NHAI/PIU-KNW/NH-347BG/PKG-IV/Forest/2022-23/1292

Date: 17.02.2023

Sub: 4-laning of Dhangaon – Boregaon section of NH-347BG & 753L (Indore to Boregaon- Pkg IV) Design Ch 81.000 to 139.000 (Length 58.000 Km) under Bharatmala Pariyojana Phase-I in the State of Madhya Pradesh on Hybrid Annuity Mode – Submission of Compliance of EDS raised by IRO regarding Forest Diversion proposal to an extent of 4.138 Ha. - Proposal No. FP/MP/ROAD/152561/2022 - Reg.

COMPONENT WISE BREAKUP OF LAND REQUIRED AND AREA CALCULATION

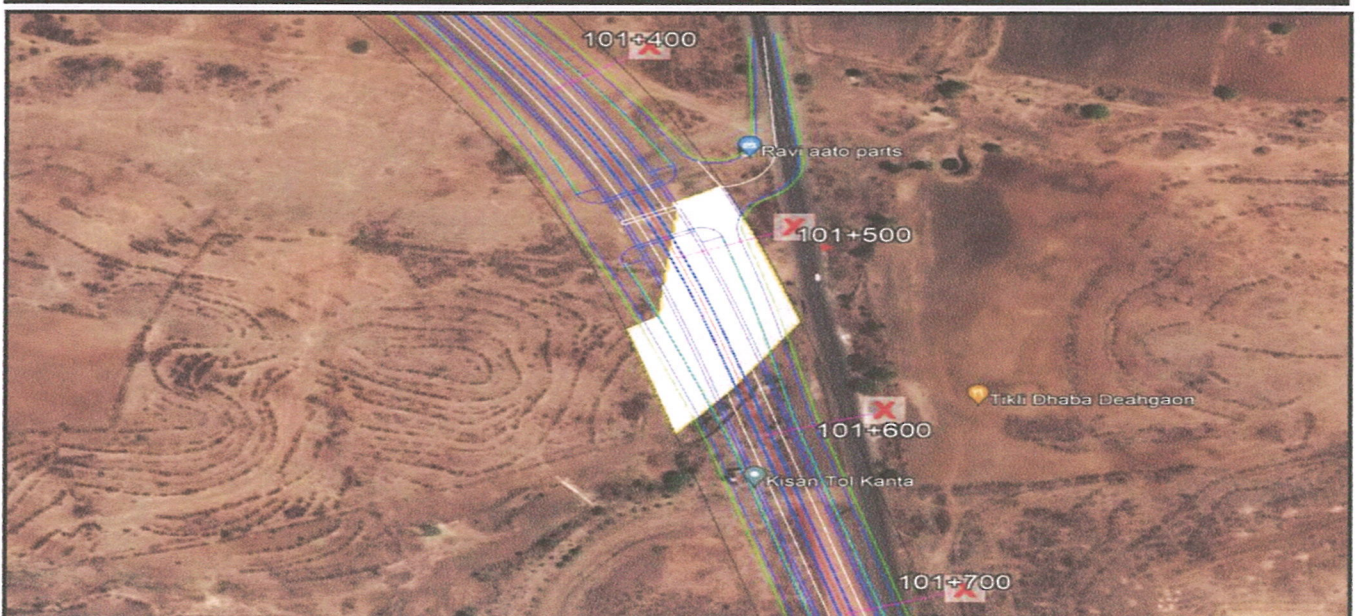
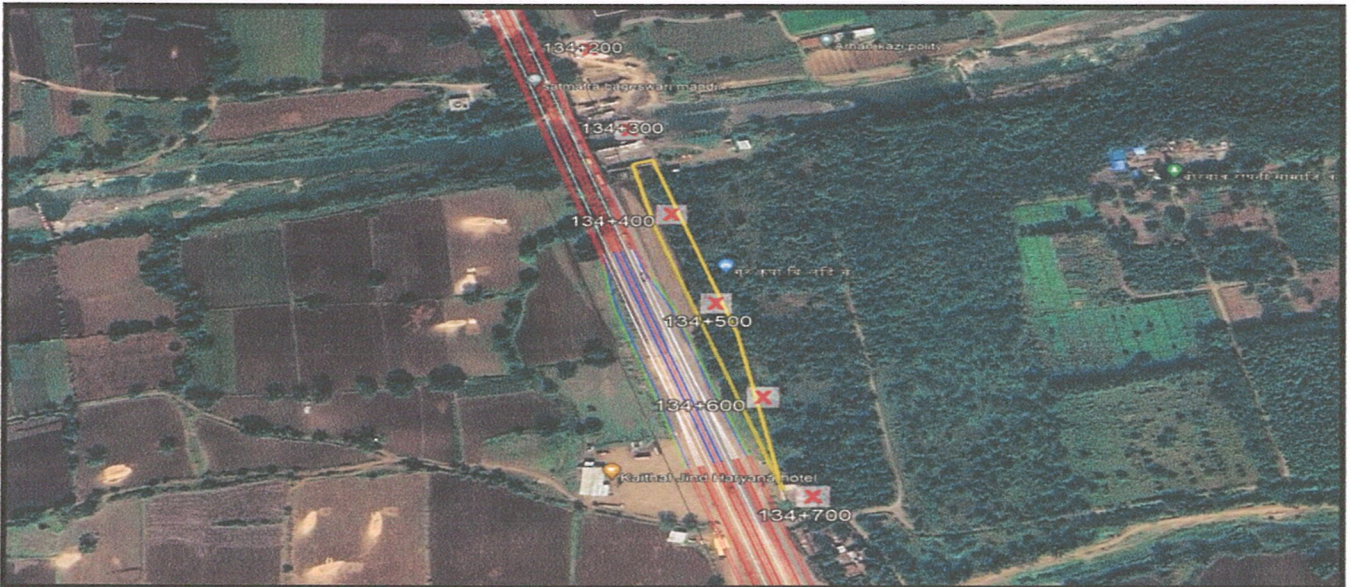
5.	Component wise breakup of land required and component wise area calculation with the layout plan is required.	Component wise breakup of land is attached herewith along with layout plan

S.NO	COMPONENT	LENGTH	WIDTH	AREA IN HA	REMARK
1	ROAD	1454.33	Varies	4.138	
Total Land Required				4.138

Component	From	To	Length in M	Avg. Width in m	Required Area in Ha
Barwah Division					
Road	81+000	82+000	1069	30	3.207
Khandwa Division					
Road	101+500	101+600	78	60	0.47
Road	134+300	134+700	307.33	15	0.461
Khandwa Division Sub Total			385.33	75	0.929
Barwah + Khandwa Division			1454.33	90	1.390

RF No	From	To	Length in M	Avg. Width in m	Required Area in Ha
Barwah Division					
291	81+000	82+000	1069	30	3.207
Khandwa Division					
U-663	101+500	101+600	78	60	0.47
Revenue Forest	134+300	134+700	307.33	15	0.461
Khandwa Division Sub Total			385.33	75	0.929
Barwah + Khandwa Division			1454.33	90	1.390
